MAY 08 2017

**ACTION ITEM FOLLOW-UP IN SUPPORT OF U.S. NUCLEAR REGULATORY
COMMISSION SALT WASTE DISPOSAL MONITORING ACTIVITIES**

Figure 1. Solubility of $TcO_2 \cdot 1.6H_2O_{(s)}$ (upper graph) and $TcO_2 \cdot 1.6H_2O_{(am)}$ (lower graph) as a function of pH in the AGW solution and the more concentrated version ($[CO_2] = 0$ mol/L).

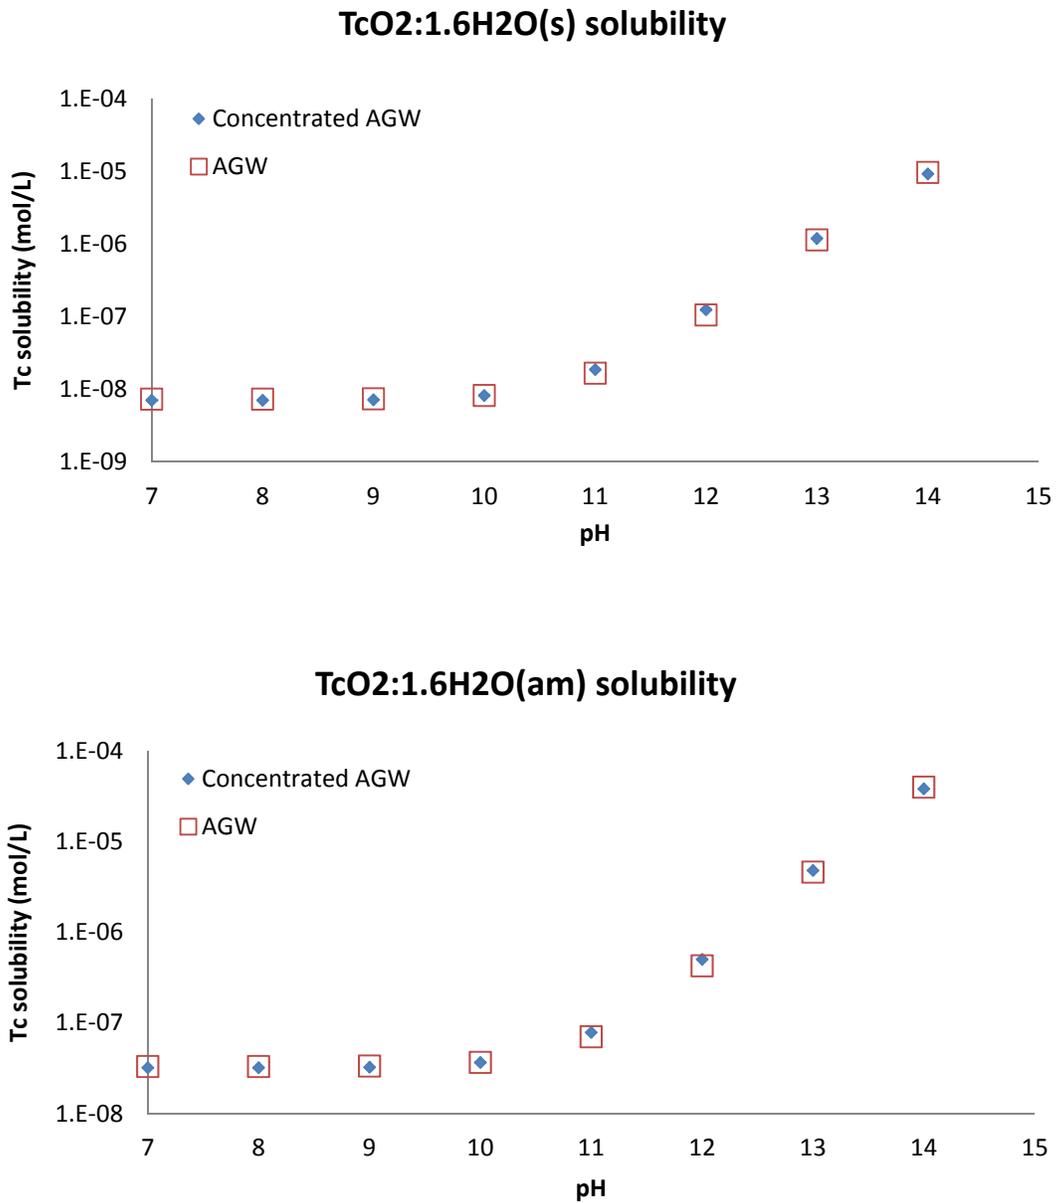
- The NRC technical staff received the DOE response to the previous NRC question about the units in Table 2-4 of SRNL-STI-2016-00106:
 - The previous NRC question: *Verify that the units used in the table are correct (g/L) or, if not correct, then provide the NRC with the correct units for the table.*
 - The DOE response: *The units (g/L) are correct.*
- As a follow up, the NRC technical staff requests additional clarifying information from the DOE:
 - Table 2-4 of SRNL-STI-2016-00106 provides the composition of the leachate used; however, the document does not provide a basis for that solution composition.

- That basis is unclear to the NRC staff because the solution appears to be more than three orders of magnitude more concentrated in major ions (e.g., Ca²⁺, Cl⁻, Na⁺) than SRS groundwater; but does not have the expected composition (e.g., high nitrate concentration) of saltstone-leachate-impacted water.
- *Please clarify the basis for the solution composition provided in Table 2-4 of SRNL-STI-2016-00106.*
- *If the composition of the leachate differs from anticipated field conditions, then please describe how that may impact radionuclide release.*

Technetium-99 retention was quite similar for all SDU samples regardless of the equilibration atmosphere, with the final concentration of ⁹⁹Tc ranging from $\approx 7.02 \times 10^{-9}$ to 3.95×10^{-8} M. The solubility of several technetium phases at the pH of the batch test is presented in Table 1. Solubility estimates as a function of solution conditions were determined using the PHREEQC Version 3 computer code for aqueous geochemical calculations (Parkhurst, D.L., and Appelo, C.A.J., 2013) and the accepted thermodynamic databases (Thermodem_V1.10; LLNL Database). Under anoxic conditions the solid phase retention of ⁹⁹Tc is generally considered to be controlled by the solubility of Tc(IV)-oxide (i.e., TcO₂), with the final concentrations of ⁹⁹Tc observed in the SRNL tests similar to the levels predicted for Tc(IV)-oxide solubility at the observed pH values. The solubility of TcS_{2(s)} would support much lower ⁹⁹Tc concentrations than the values reported in the current study. Figure 1 illustrates the solubility of two potential Tc(IV)-oxide solid phases as a function of pH in the low ionic strength AGW solution and the

more concentrated version. As illustrated in Figure 1, the ionic strength of the background solution has a very limited impact on the solubility of the Tc(IV)-oxide.
